SITE PLAN REVIEW COMMITTEE

1. APPLICATION FOR SITE PLAN APPROVAL
17844 LESLIE STREET – WARD 3
(SOUTH WEST CORNER OF LESLIE STREET AND JANETTE STREET)
OUR FILE NO.: D14-NP1410
2398804 ONTARIO INC.

2. APPLICATION FOR AMENDMENT TO SITE PLAN APPROVAL 16635 YONGE STREET – WARD 6 (NORTH EAST CORNER OF YONGE STREET AND SAVAGE ROAD) OUR FILE NO.: D11-NP1516 SKAMARI INVESTMENTS INC.

REVIEW NOTES

17844 LESLIE STREET

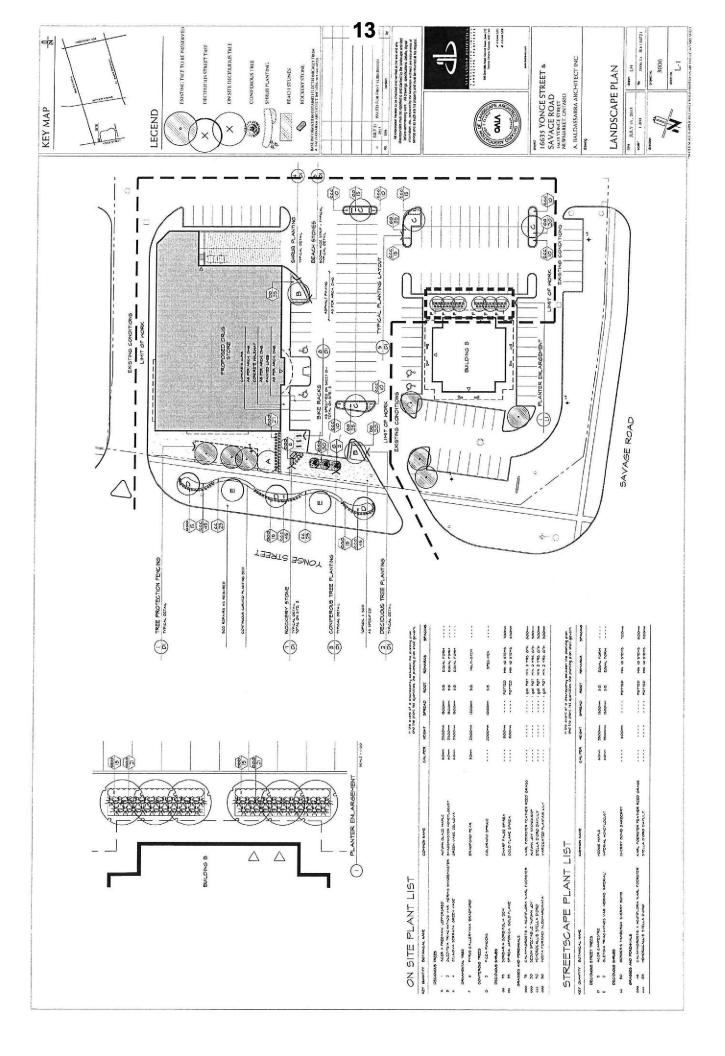
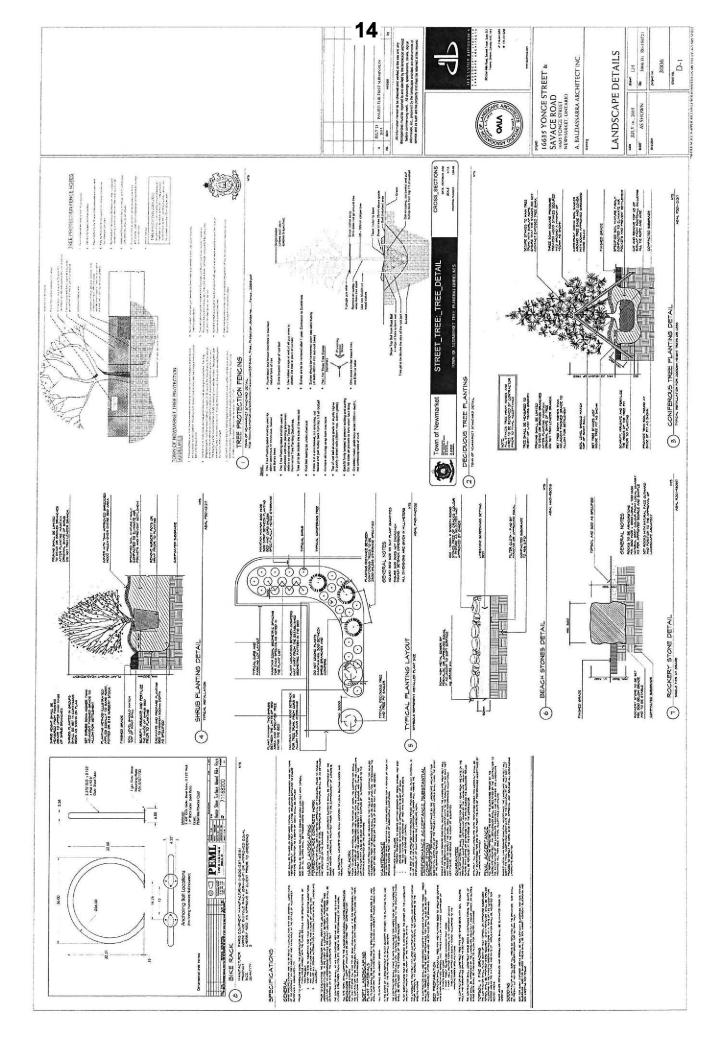
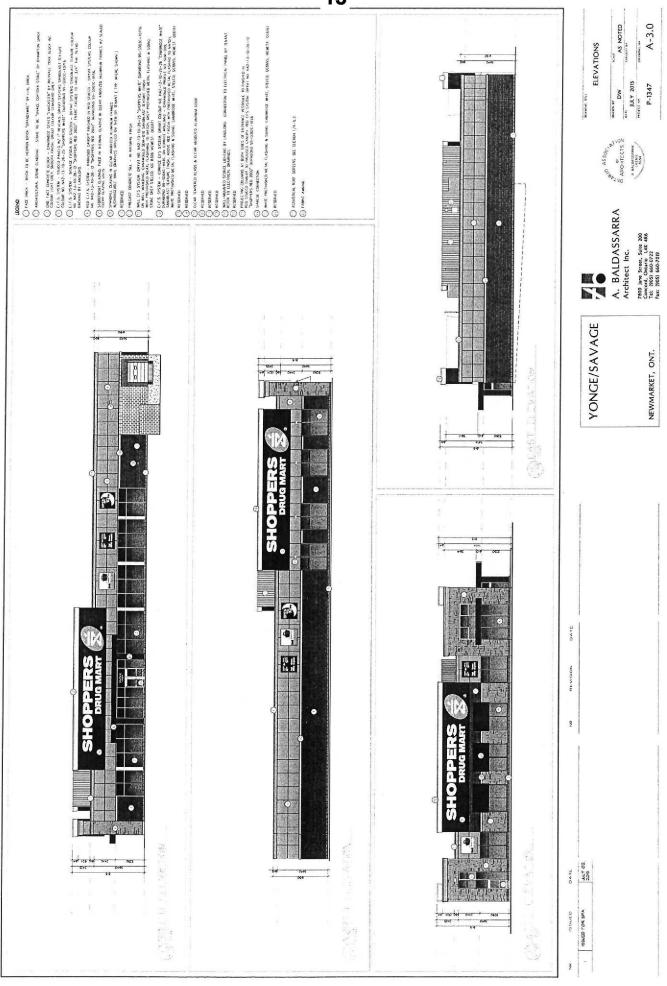
- Parking numbers and building setbacks appear satisfactory; spaces 3 and 4 may need to be relocated from area of underground fuel storage tanks
- Bicycle parking spaces are required in accordance with provisions of zoning by-law

- Tanker truck movements to be shown on Site Plan.
- Details of garbage storage required; show location of enclosure on plans
- Snow storage areas to be shown on plans

- Zoning By-law requires provision of an opaque wooden fence 1.8 metres in height along westerly property line
- Daylighting triangle to be clearly shown on all plans

- Stormwater to be maintained on site; incorporate elements of low impact development into site
- Construction Management Plan (CMP) required prior to issuance of any building permit

- Compliance with Town's Tree Preservation, Protection, Replacement and Enhancement Policy is required
- Final noise assessment report to be submitted for review; report will be peer reviewed
